Nature of Work: MP 1120 1 STORY 6 RM SFR

RIVERDALE VILLAGE 1
 "THE LANDING" FOR BEAZER HOMES
 PLOT PLAN FOR LOT 151

8810 SPARLING LN
DIXON, CA 95620
PHO: (707) 678-1636
FAX: (707) 678-5757TO: BEAZER HOMES
3721 DOUGLAS BLVD SUITE 100
ROSEVILLE CA 95661
(916) 7730425ANDERSON TRUSS
JOB INFO:
NAME: DING
JOB #: n/a
LOT #: 1151
C/O #: AS04180601RE: PLAN 1120 @ RIVERDALE NORTH
TRUSSES INSTALLED BACKWARDS

2 Wet signed truss repair for BC1, BC2, and BC3.
 2 Dry copies of signed repair for BC1, BC2, and BC3.

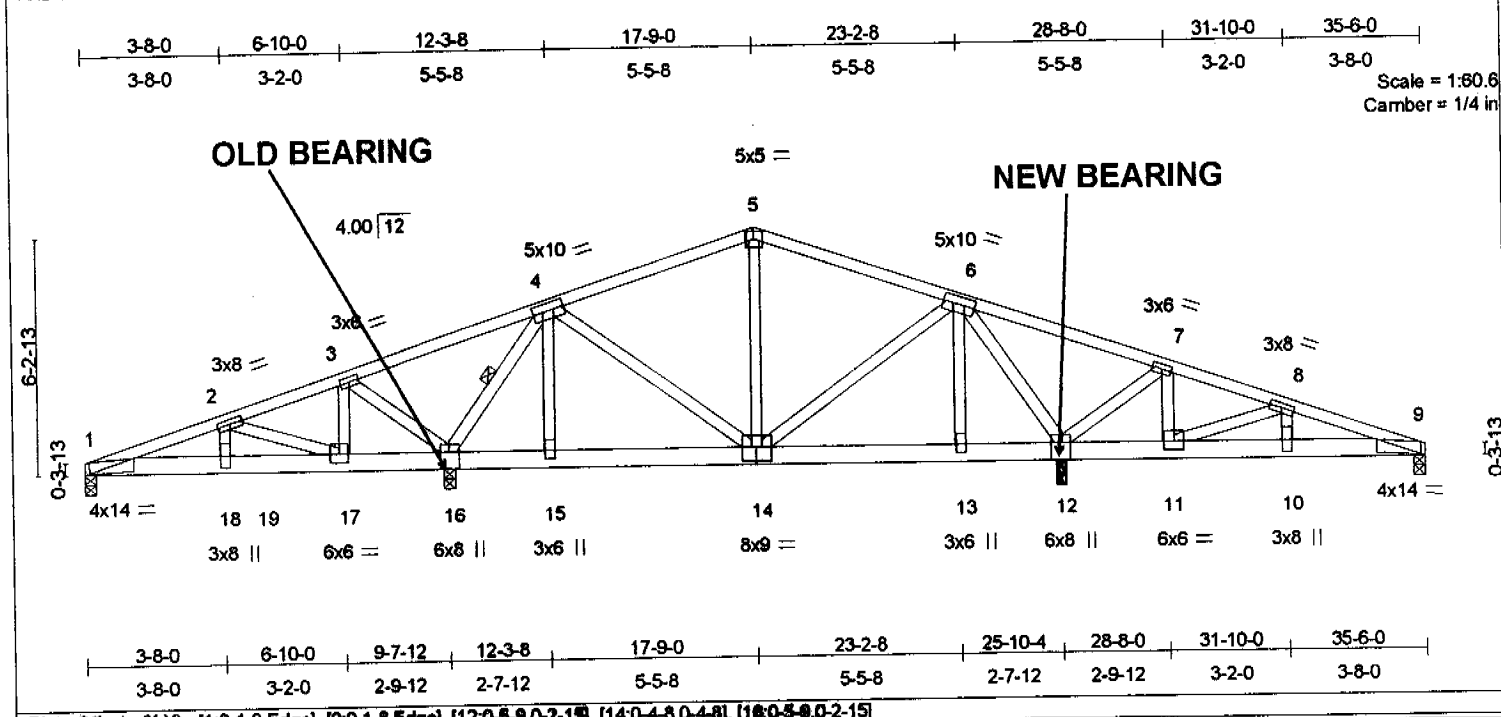
NO REPAIR REQUIRED
 TRUSS MAY BEAR AT EITHER INTERIOR LOCATION POINTED OUT ABOVE.
 TRUSS MUST BE THREE POINT BEARING, ONE AT EACH END AND ONE INTERIOR, SYMETERICAL DESIGN ALLOWS FOR THIS INSTANCE.

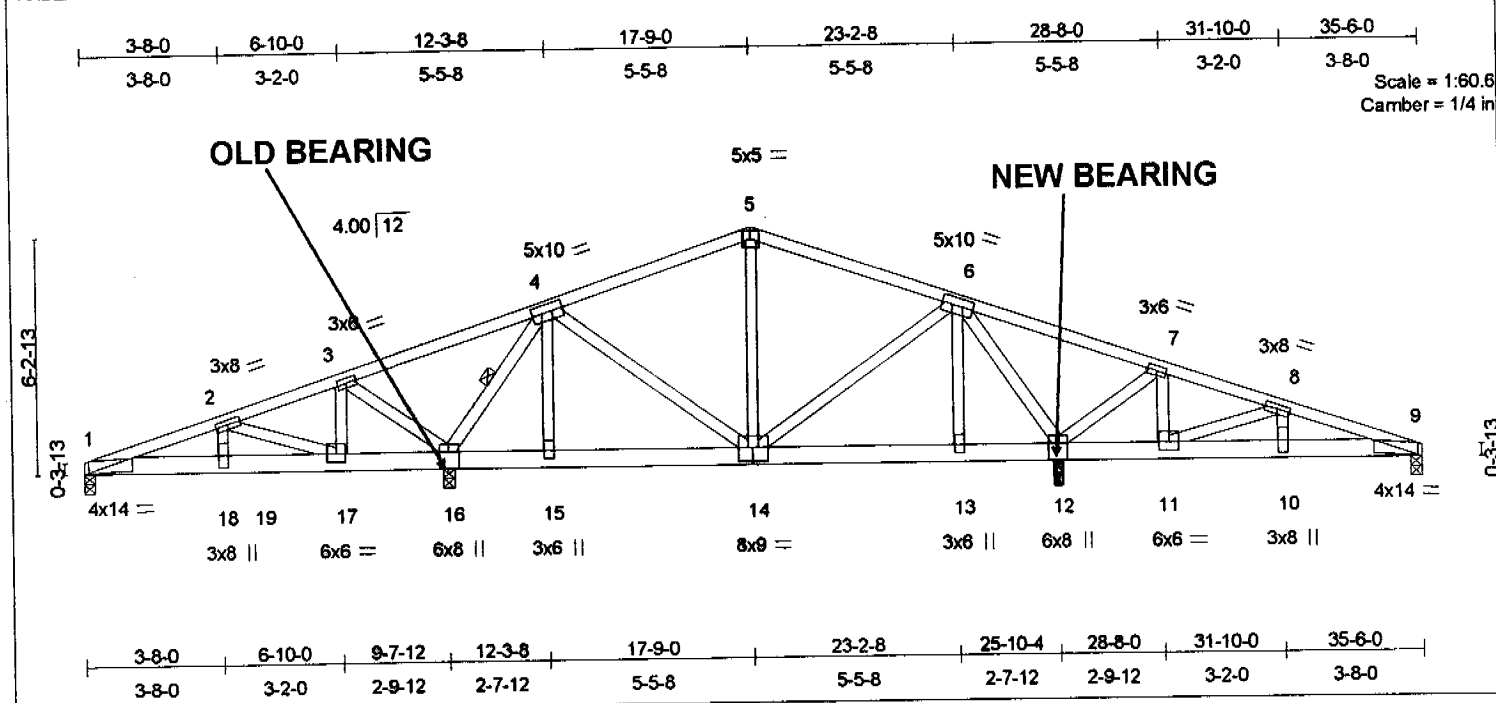
NO REPAIR REQUIRED
 TRUSS MAY BEAR AT EITHER INTERIOR LOCATION POINTED OUT ABOVE.
 TRUSS MUST BE THREE POINT BEARING, ONE AT EACH END AND ONE INTERIOR, SYMETERICAL DESIGN ALLOWS FOR THIS INSTANCE.

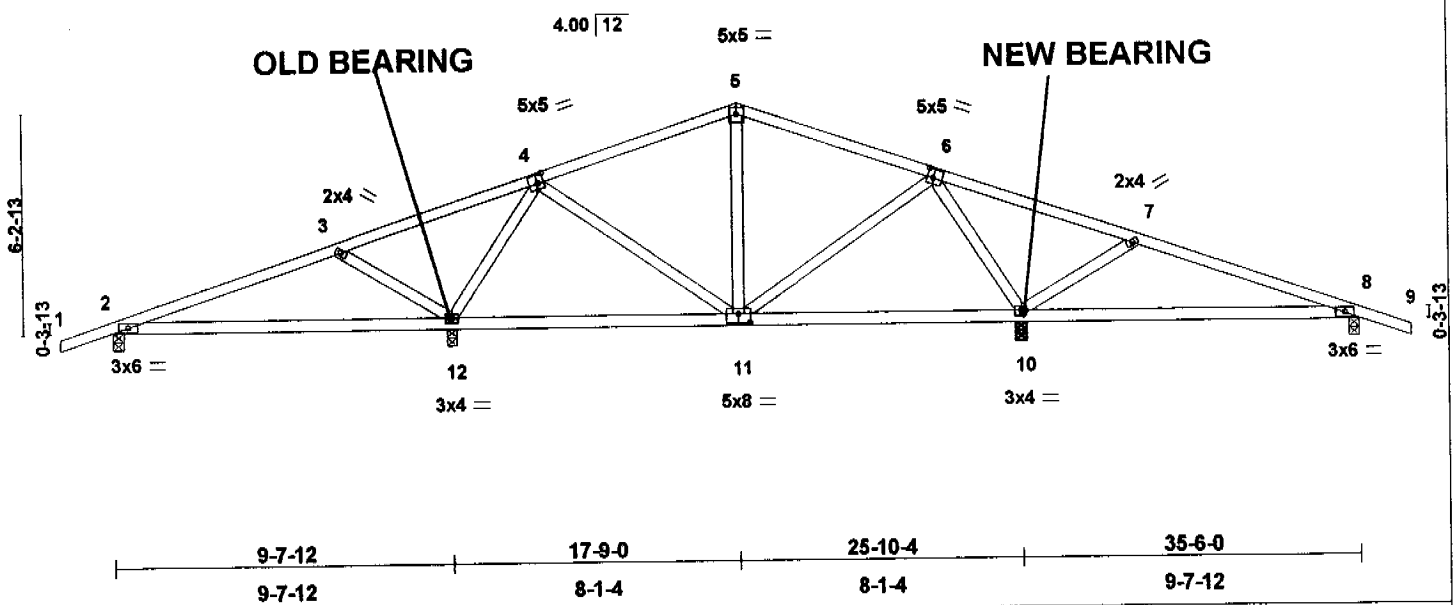
NO REPAIR REQUIRED
TRUSS MAY BEAR AT EITHER LOCATION POINTED OUT ABOVE.
TRUSS MUST BE THREE POINT BEARING, ONE AT EACH END AND ONE INTERIOR, SYMETERICAL DESIGN ALLOWS FOR THIS INSTANCE.

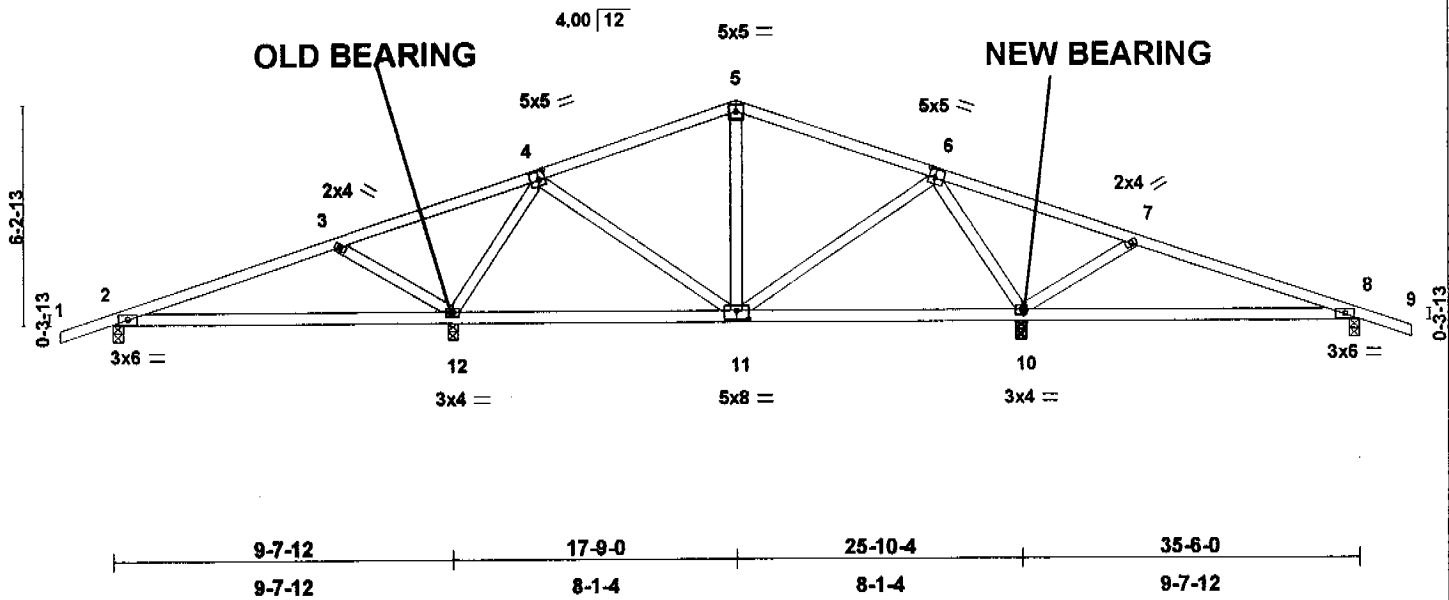
NO REPAIR REQUIRED
 TRUSS MAY BEAR AT EITHER LOCATION POINTED OUT ABOVE.
 TRUSS MUST BE THREE POINT BEARING, ONE AT EACH END AND ONE INTERIOR, SYMETERICAL DESIGN ALLOWS FOR THIS INSTANCE.

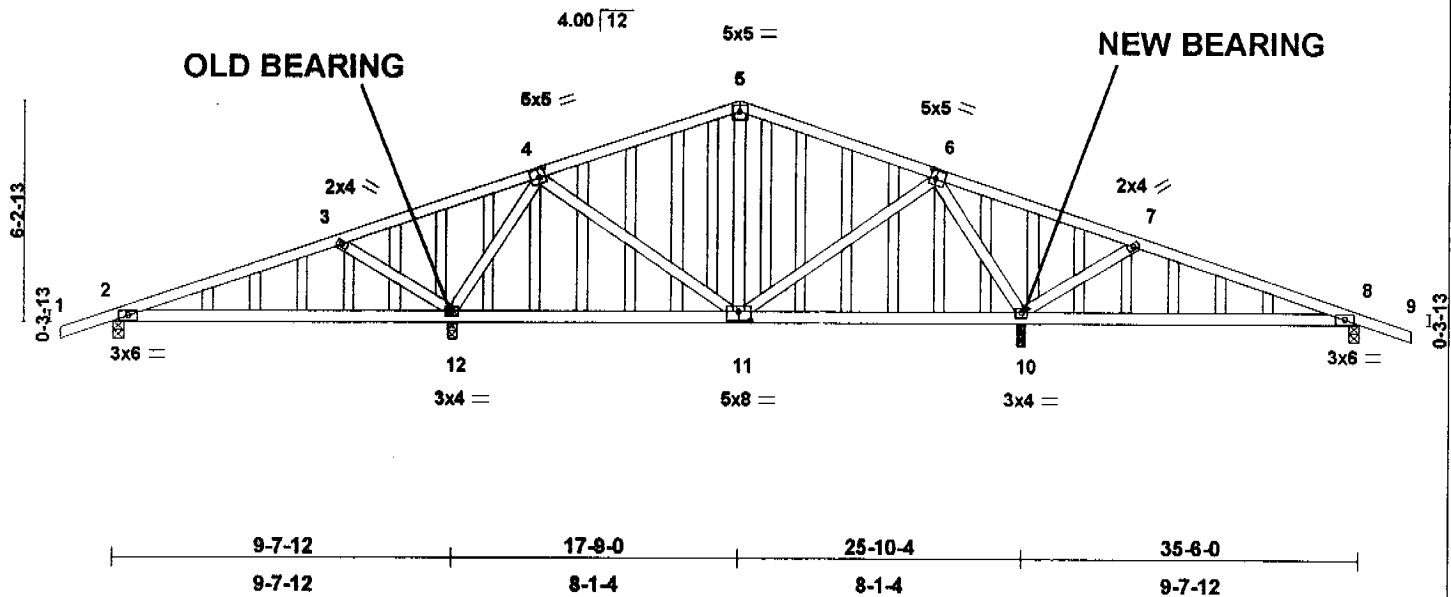
NO REPAIR REQUIRED
TRUSS MAY BEAR AT EITHER INTERIOR LOCATION POINTED OUT ABOVE. TRUSS MUST BE THREE POINT BEARING, ONE AT EACH END AND ONE INTERIOR, SYMETERICAL DESIGN ALLOWS FOR THIS INSTANCE.

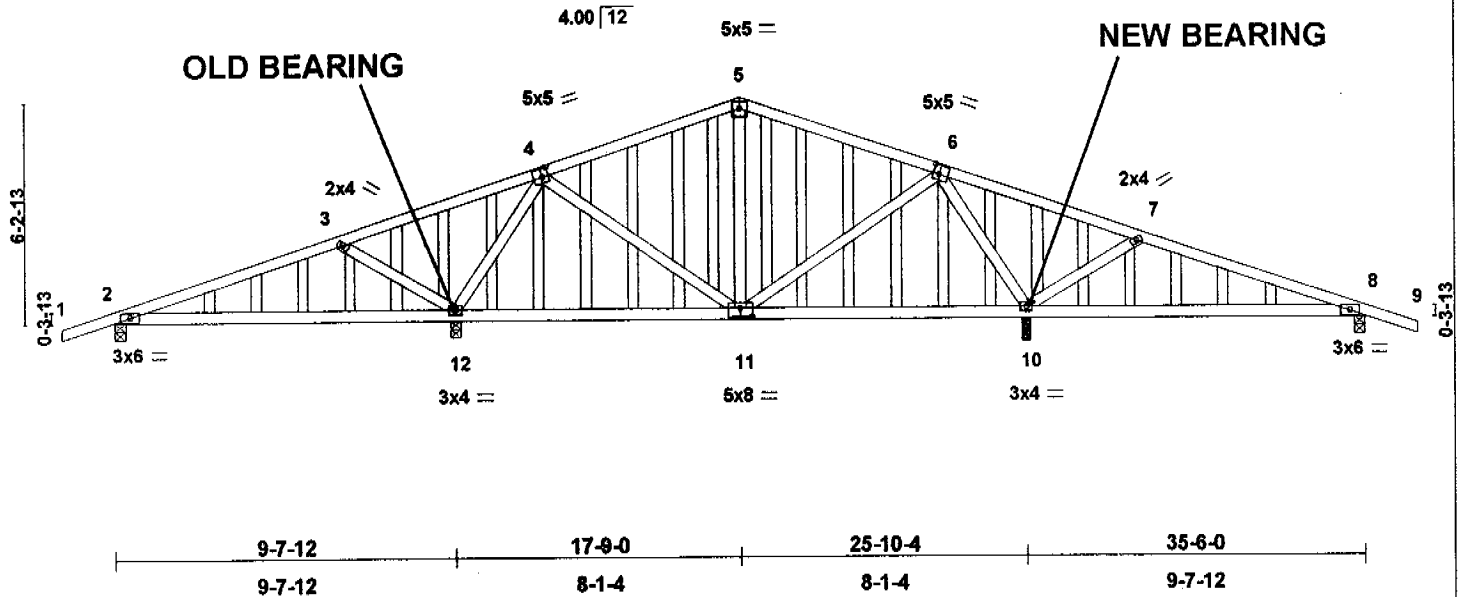
NO REPAIR REQUIRED
TRUSS MAY BEAR AT EITHER INTERIOR LOCATION
POINTED OUT ABOVE. TRUSS MUST BE THREE POINT
BEARING, ONE AT EACH END AND ONE INTERIOR,
SYMETERICAL DESIGN ALLOWS FOR THIS INSTANCE.

Job 1120	Truss BC1	Truss Type DBL HOWE	Qty 1	Ply 2	BEAZER / LANDING @ RIVERDALE 1120 COLLECTOR TRUSS #2900 Job Reference (optional)
ANDERSON TRUSS DIXON, DIXON, CALIFORNIA 95620			6 200 s Jan 10 2005 MITek Industries, Inc. Tue Aug 02 14:42:34 2005 Page 1

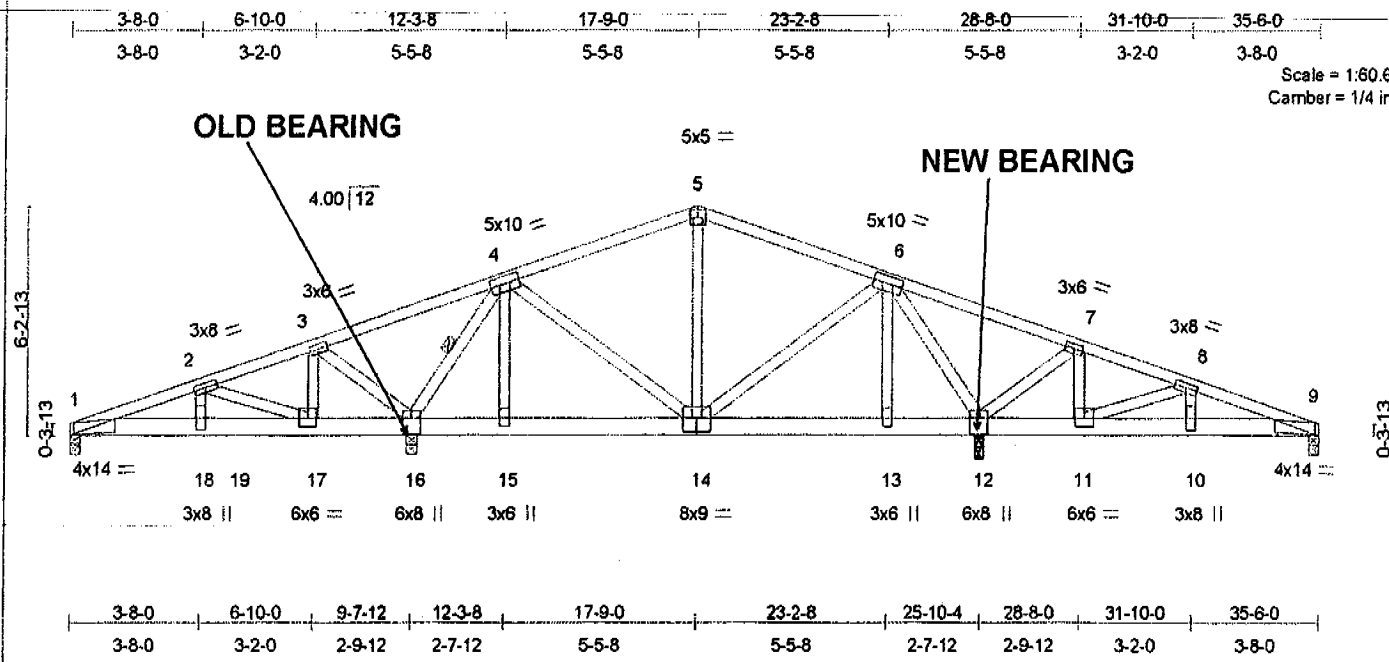
NO REPAIR REQUIRED
TRUSS MAY BEAR AT EITHER INTERIOR LOCATION POINTED OUT ABOVE.
TRUSS MUST BE THREE POINT BEARING, ONE AT EACH END AND ONE
INTERIOR, SYMETERICAL DESIGN ALLOWS FOR THIS INSTANCE.
